Application No. 10/618,133
Combined Amdt. And Response mailed April 15, 2005
Attorney Docket No. ARA-US-P1

AMENDMENTS TO THE DRAWINGS

FIG. 13

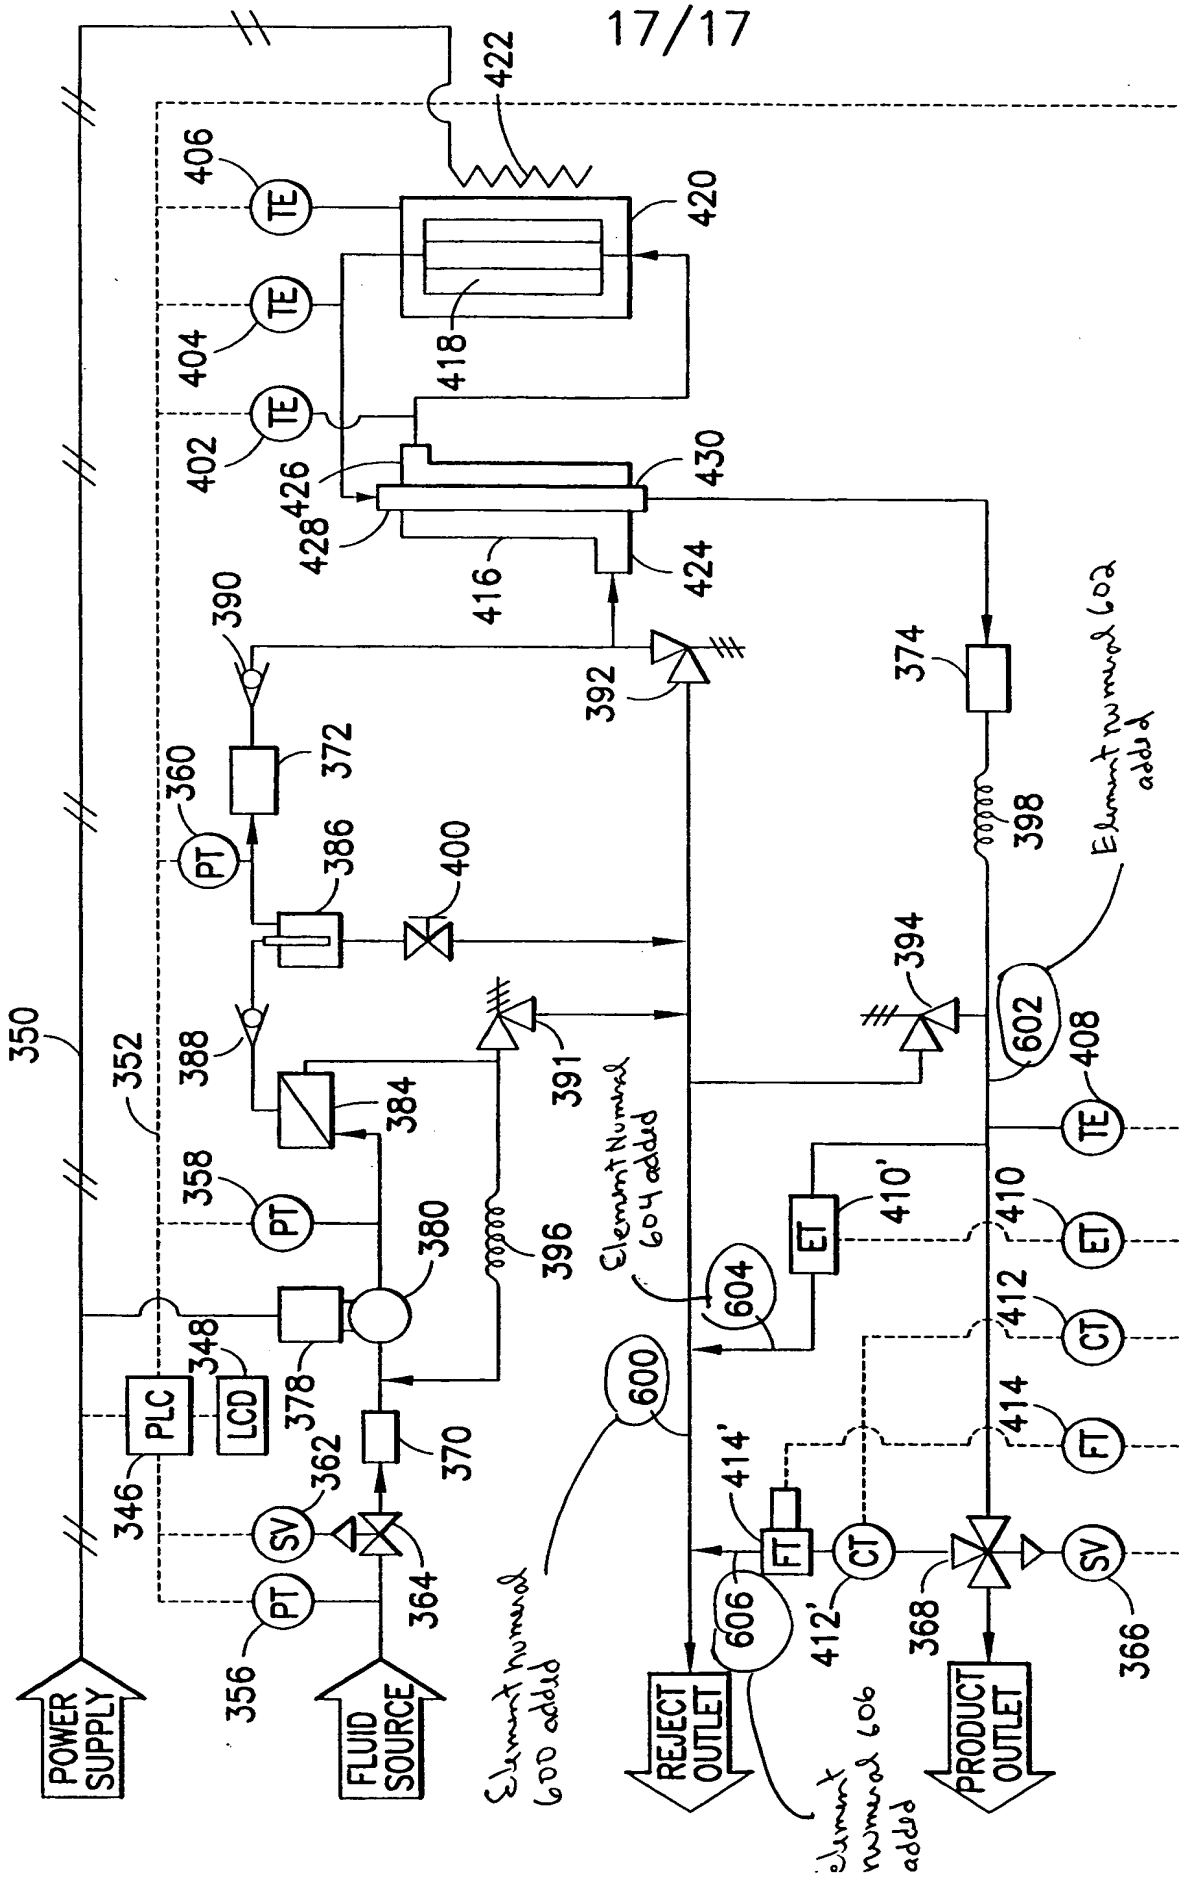
The paragraph at page 35, line 15-22 has also been amended to make it clear that a portion of the product fluid from the second flow restrictor 398 is diverted from the product line via a sampling line 604 to pass through an endotoxin sensor 410'. Support for this amendment can be found in FIG. 13 which shows a line (element numeral 604 in amended FIG. 13) leading away from product line 602 and going towards reject line 600. It is clear from FIG. 13 that line

604 diverts a portion of the product fluid flowing from the second flow restrictor so as to pass through endotoxin sensor 410' disposed along line 604. Since line 604 diverts a portion of the product fluid so that the endotoxin level of product fluid can be measured, line 604 is a "sampling line". No new matter has been added by this amendment. See above: MPEP 608.04; *Vas-Cath*, 935 F.2d at 1565, 19 USPQ2d at 1118; *Autogiro*, 384 F.2d 391, 398, 155 USPQ 697, 703; and *In re Wolfensperger*, 133 USPQ at 542 (CCPA 1962).

In amended FIG. 13, previously omitted element numerals 600, 602, 604 and 606 have been added. No new matter has been added by these amendments.

The attached sheet of drawings includes changes to FIG. 13. This sheet, which includes FIG. 13, replaces the original sheet including FIG. 13. In amended FIG. 13, previously omitted element numerals 600, 602, 604 and 606 have been added.
